STAFF REPORT

SUBJECT: H-2021-0019 & A-2021-0063
Mountain America Credit Union – CUP & DES

Conditional use permit for a drive-through establishment within 300-feet of another drive-through establishment on 1.16 acres of land in the C-G zoning district and concurrent Administrative Design Review.

A. Proposed Site Plan (dated: 3/23/2021)

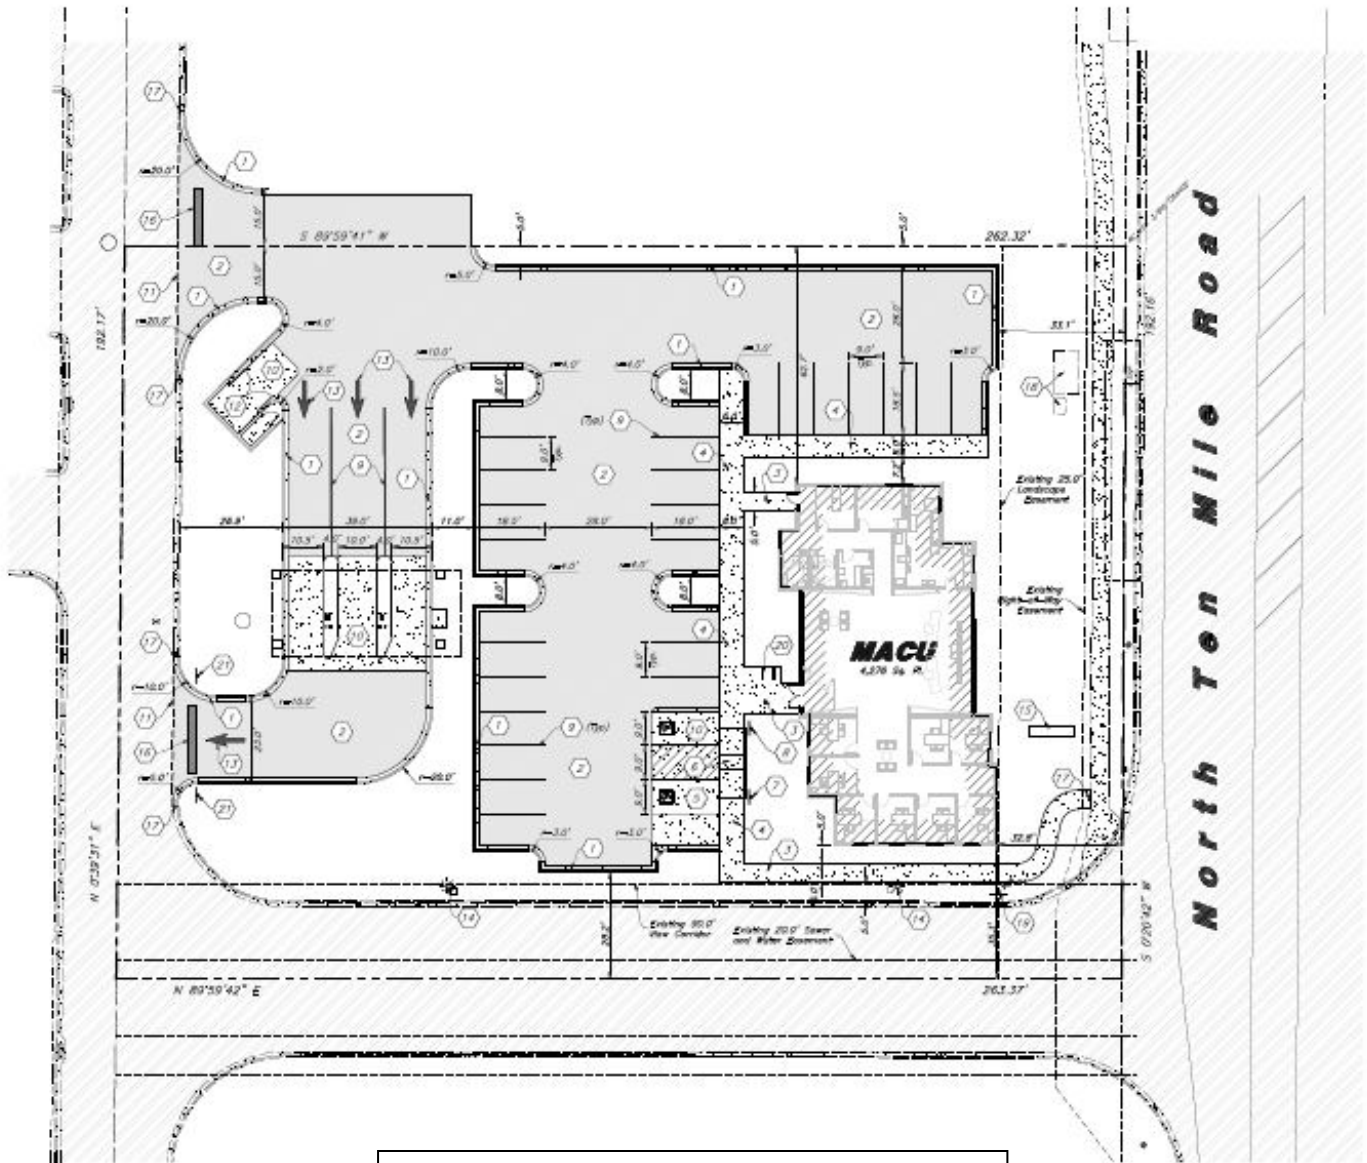
The proposed drive-through has three (3) stacking lanes that are approximately 65’ +/- from the drive aisle to the drive-up services for the bank; furthermore, the proposed drive-up services are proposed in a detached structure that is on the west end of the site with the main building being on the east of the site, approximately 95’ apart. Staff believes the stacking lane has sufficient capacity to serve the use without obstructing driveways and drive aisles by patrons.

Per the submitted site plan, the stacking lanes are off of the shared internal access and provide at least 65’ of are before any vehicle would impede any access. Staff does not foresee the stacking lanes impeding the circulation lanes, especially due to the proposed design of a detached drive-through.

The stacking lanes do not exceed 100' in length so no escape lane is proposed. However, the exit drive-aisle for the detached drive-through is shown as 23' wide, allowing for patrons to exit the drive-through and turn north or south with ample room on either side.

The detached drive-through is not exceptionally visible from N. Ten Mile Rd. (the closest public street) along the east boundary of the site but the south boundary of the site is one of the main ingress and egress drive aisles for the overall Costco site. Staff finds this shared drive-aisle and overall proximity to Ten Mile Road (no more than 185 feet in distance) provides for adequate surveillance opportunities.

Parking: A minimum of one (1) parking space is required to be provided for every 500 square feet of gross floor area for nonresidential uses. The proposed building is shown as 4,276 square feet requiring a minimum of 9 (rounded up from 8.5) parking spaces; the submitted site plan shows 30 proposed parking spaces exceeding UDC minimums.

A minimum 5-foot wide landscape buffer is required to be provided along the perimeter of the parking or other vehicular use areas as set forth in UDC 11-3B-8C.1. The submitted landscape plan shows the required perimeter buffer but the buffer along the north boundary does not show any trees within this buffer. Trees are required to be provided for within these buffers at a ratio of at least 1 tree every 35 linear feet. **With the CZC submittal, the landscape plan should be revised to show compliance with this standard.**

2. The site plan submitted with the future Certificate of Zoning Compliance application shall be revised as follows:
 - a. Depict the parking stalls in accordance with [UDC Table 11-3C-5](#) to be at least 9' wide and 19' deep unless there is at least a 2' overhang in front of the stall allowing the stall depth to be reduced to 17'.

- b. If 17' stall depths are desired abutting the proposed building, depict the sidewalk to be at least 7' in width; all sidewalks shall be at least 5' in width.

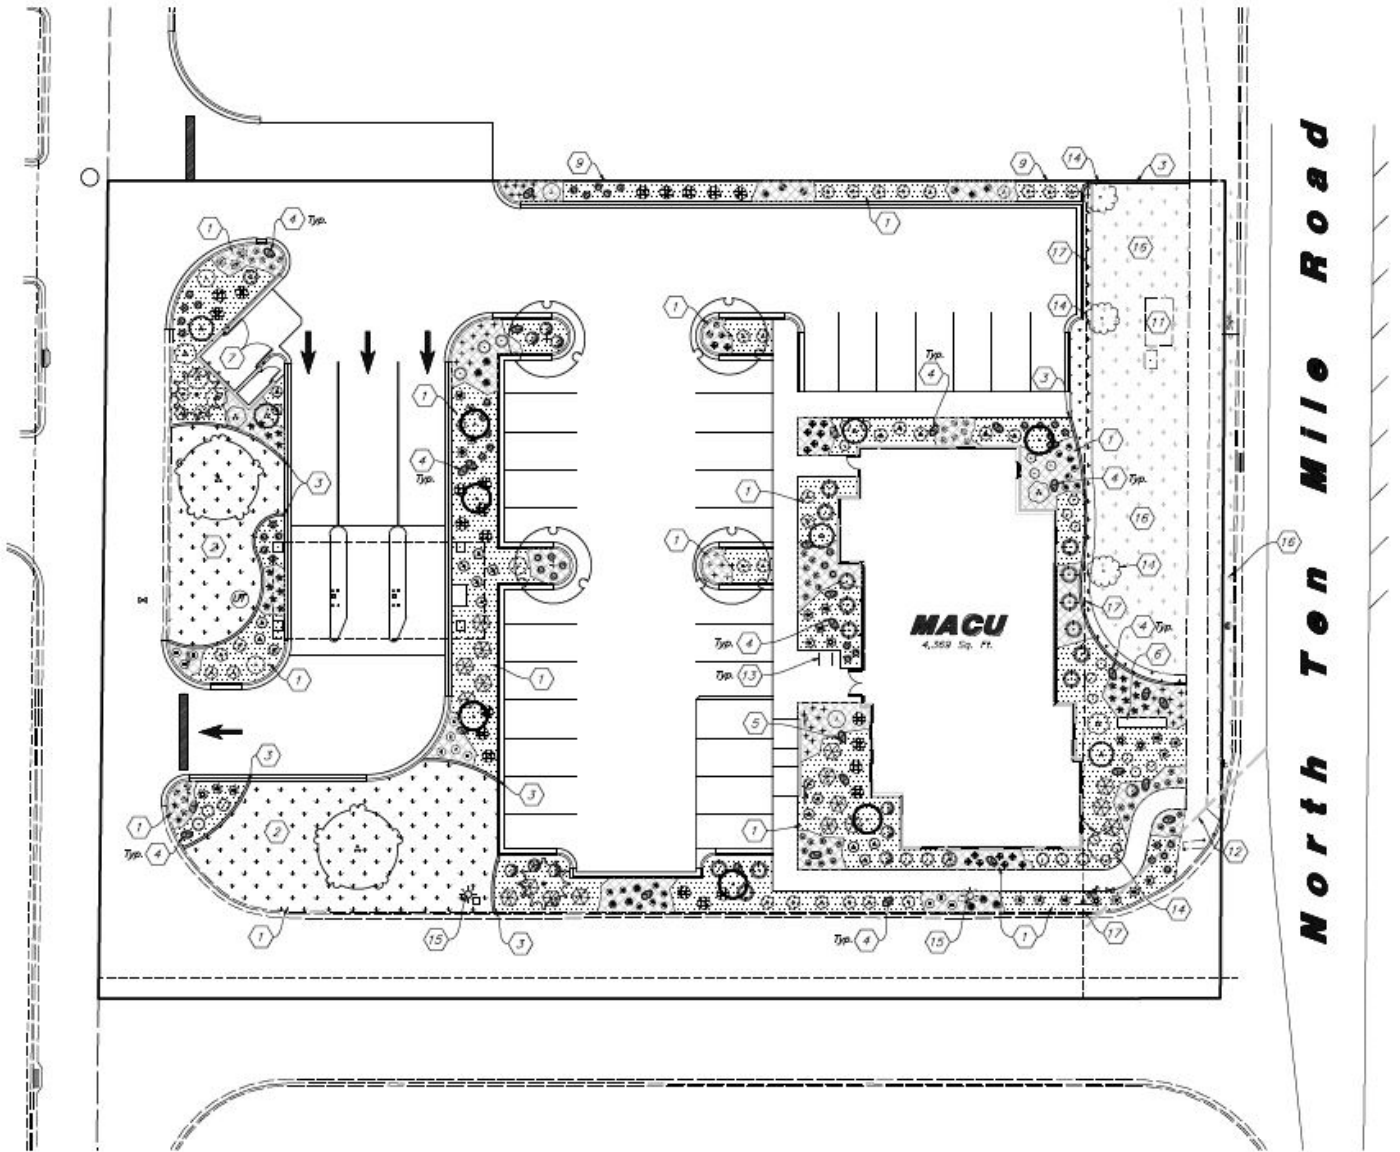
Building Elevations: The Applicant applied for Design Review concurrently with this CUP application and therefore provided building elevations to be reviewed. The building elevations were submitted as shown in Section VII.C and incorporate two main field materials, fiber cement siding and stone. The siding and stone are two contrasting colors (coal-like color and white, respectively) which adds to the overall modern design of the building. On the east and west elevations, the number of proposed windows can act as either an accent material or a third field material. The lack of modulation along the north and south elevations are of concern to Staff. In order to meet the modulation requirements for these two facades, a column of stone at least 6 inches in depth should be added to each façade, matching the overall aesthetic by placing them as evenly as possible on each façade.

The detached drive-through canopy is shown with the same two field materials (fiber cement siding and stone) as the main building and meets all of the applicable design standards outlined in the Architectural Standards Manual.

4. The elevations submitted with the Administrative Design Review (DES) application are approved with the following revisions:
 - a. Show the north and south elevations with additional qualifying modulation per standard 3.1A & 3.1B in the [Architectural Standards Manual](#). The revisions to the elevations are required with the submittal of the certificate of zoning compliance application.
